Report of the Internal Review Board for the choice of a baseline configuration for the stable recycling cavities of Advanced Virgo+

Internal Review Board:

Long cavity layout

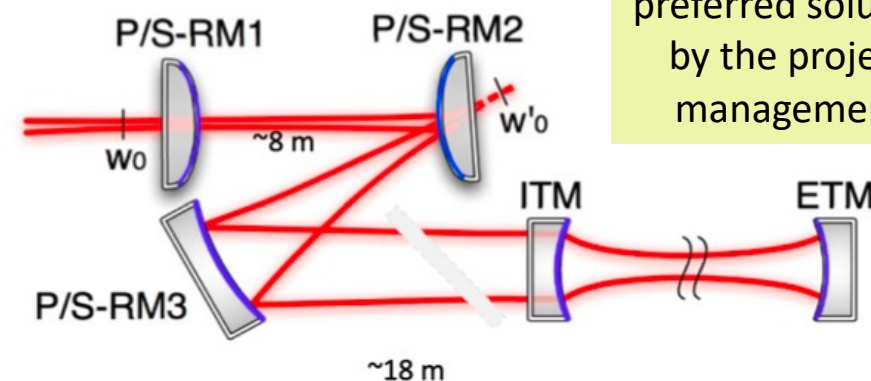
It requires the construction of additional external building + tunnels for the vacuum tubes

Limited activity in the central building
